These amendments relate to the replacement of 81 of the 157 fuel assemblies in the reactor core of Surry Unit No. 2 constituting refueling of the core for fourth cycle operation.

SUPPORTING AMENDMENTS NOS. 33 AND 32 TO LICENSES NOS. DPR-32 AND DPR-37

SURRY POWER STATION UNITS NOS. 1 AND 2

NOTICE OF ISSUANCE OF AMENDMENTS TO FACILITY  
OPERATING LICENSES

FIGURE 3.12-1B CONTROL BANK INSERTION LIMITS FOR NORMAL 3 LOOP OPERATION - UNIT 2

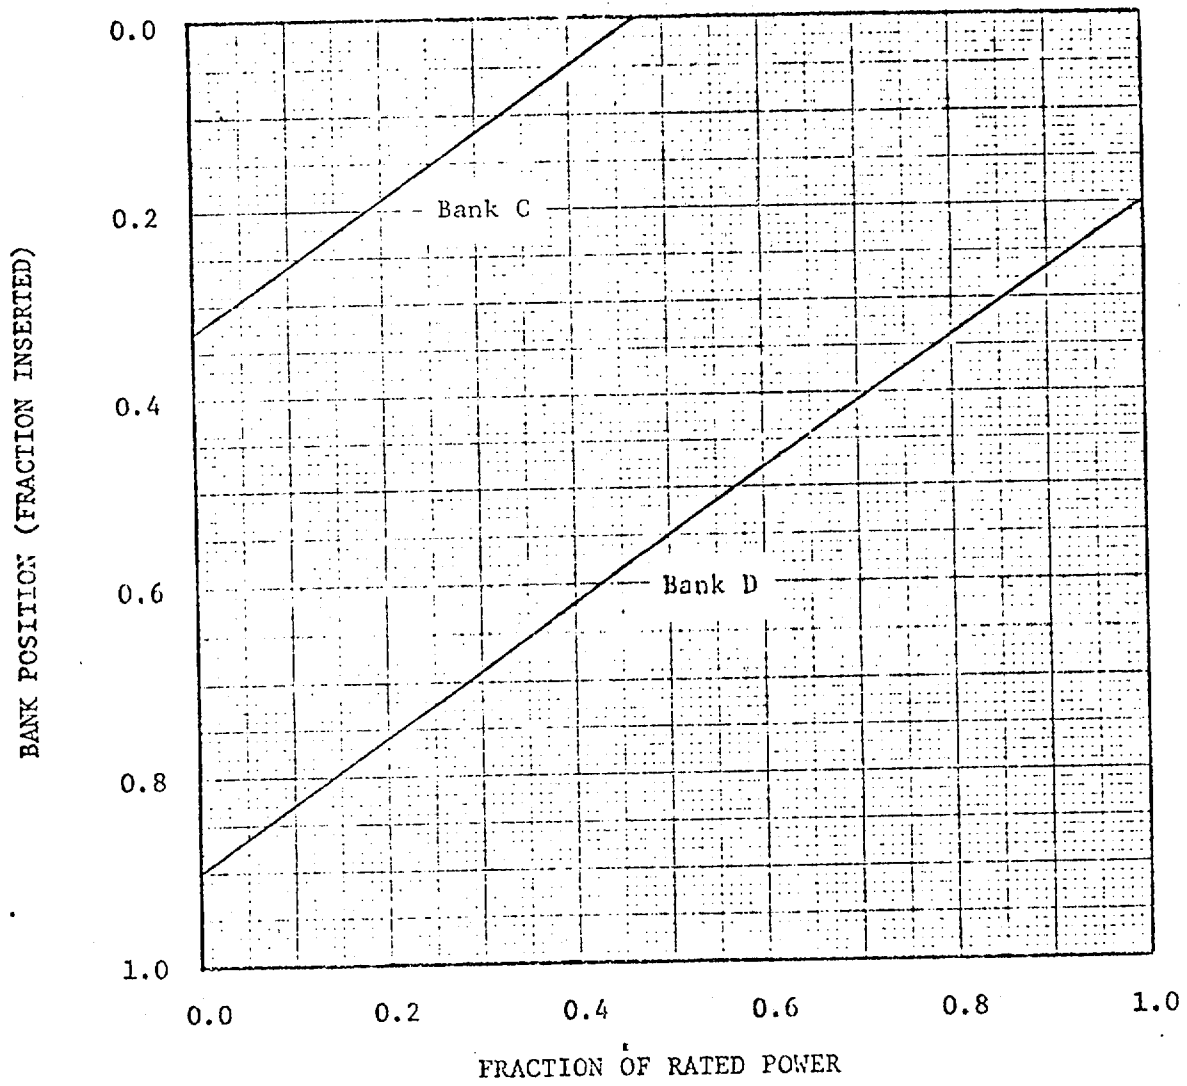
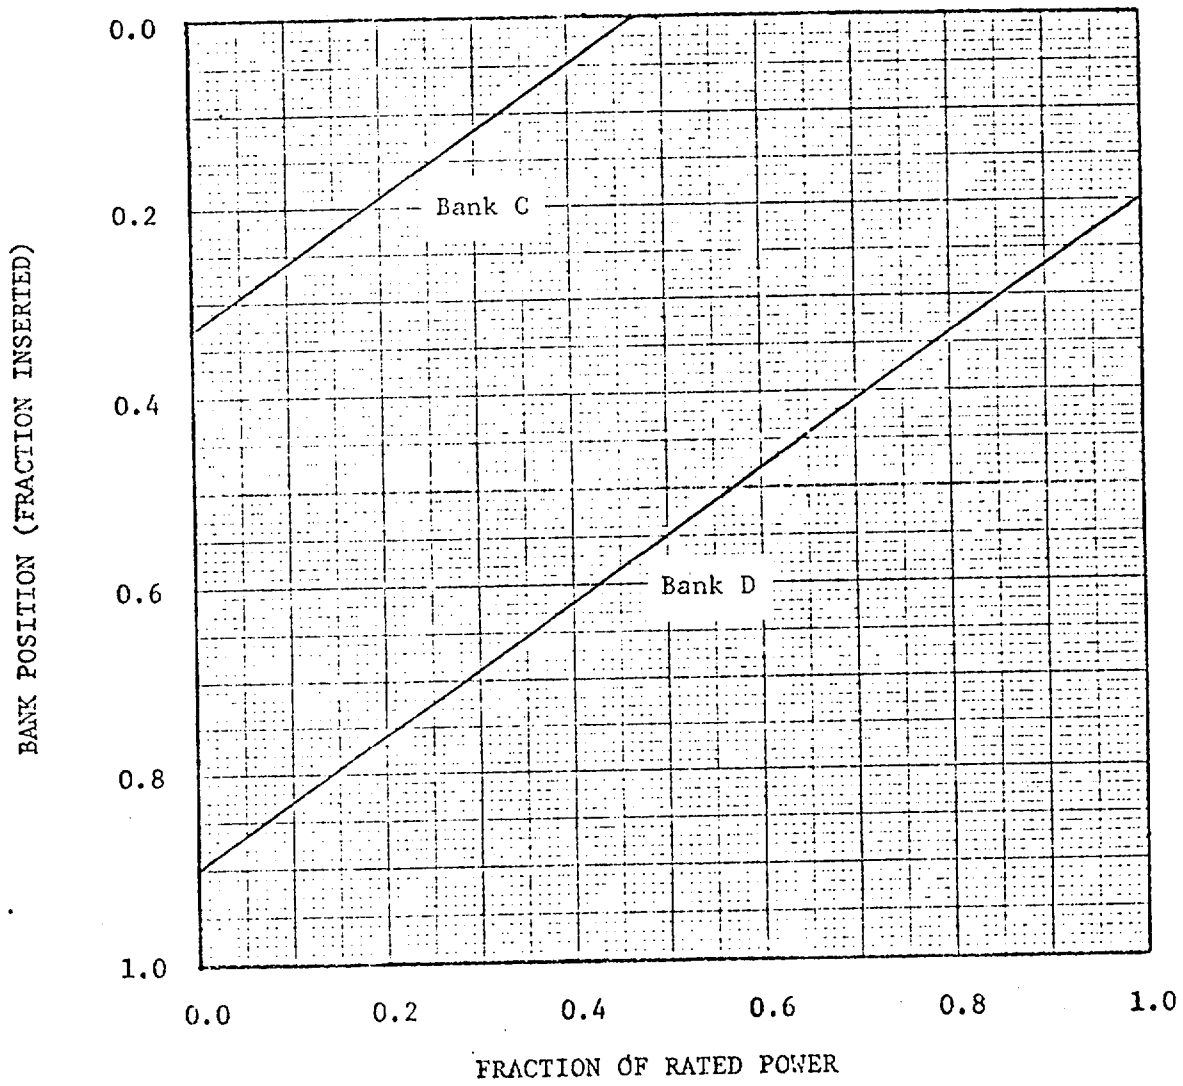
#### Control Rod Insertion Limits (T.S. Figure 3.12-1B)

The Power Dependent Insertion Limits (PDIL) proposed for Unit 2 cycle 4 are identical to those used for Unit 2 cycle 3. They were generated for Unit 2 cycle 3 assuming a cycle 2 burnup greater than 8700 MWD/MTU.

The PDIL was reviewed by the licensee to ensure that these criteria were met. It was concluded by the licensee that inputs to the cycle 3 PDIL analysis bounded the corresponding input parameters for cycle 4, and that the cycle 3 PDIL is adequate for cycle 4.

The staff concludes that since the licensee's analysis falls within the bounds of previously approved analyses the PDIL is acceptable.
